Field Service Bulletin Trucks

Radiator Tie Rod Bracket

LEU
Cummins ISL-G

FSB 261-034, Radiator Tie Rod Bracket

W2074786

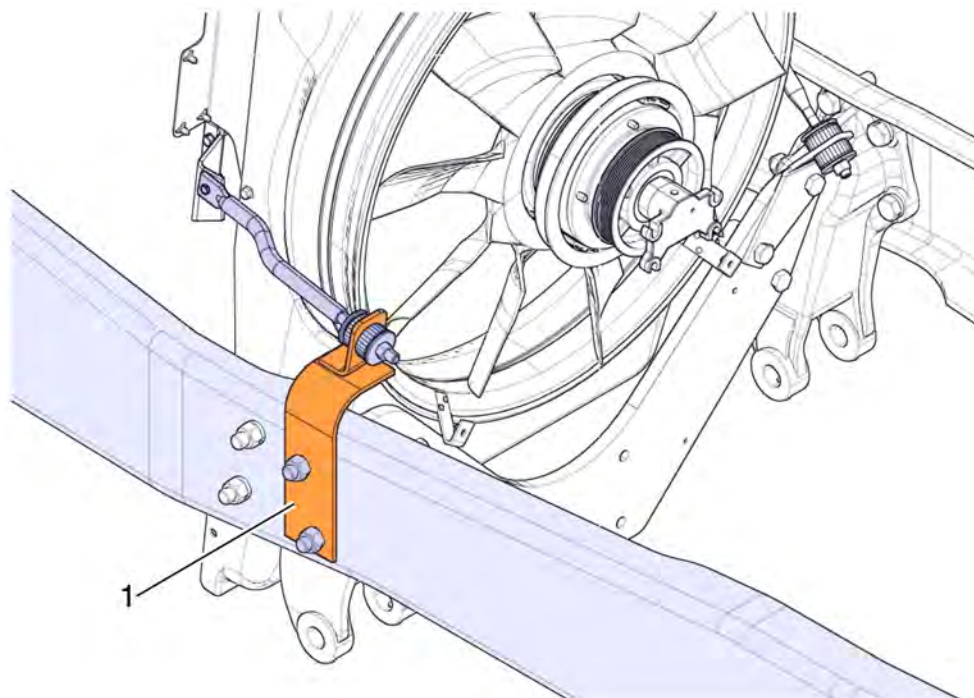
The radiator tie rod bracket (left side) on Mack LEU trucks equipped with Cummins ISL-G natural gas engines have the potential risk of making contact with the bottom of the cab. Engineering has released a new bracket that will provide the necessary clearance between the radiator tie rod bracket and the bottom of the cab. This Field Service Bulletin (FSB) will provide the correct replacement procedure for the new radiator tie rod bracket.

W2074791

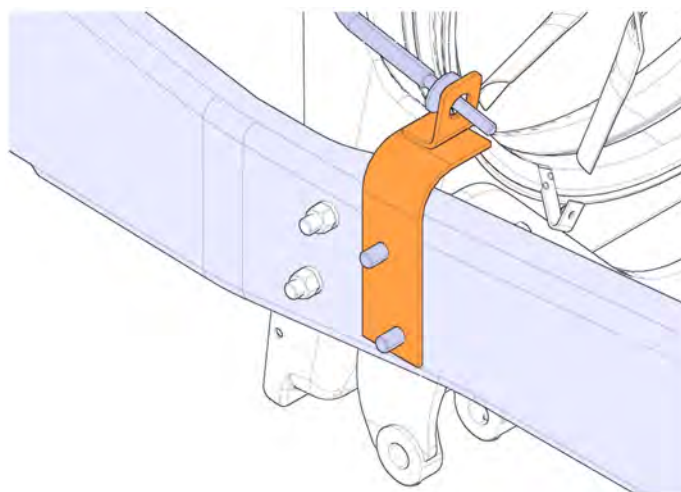
- 8 Install the replacement support bracket, position bracket over tie rod and onto the frame fasteners.
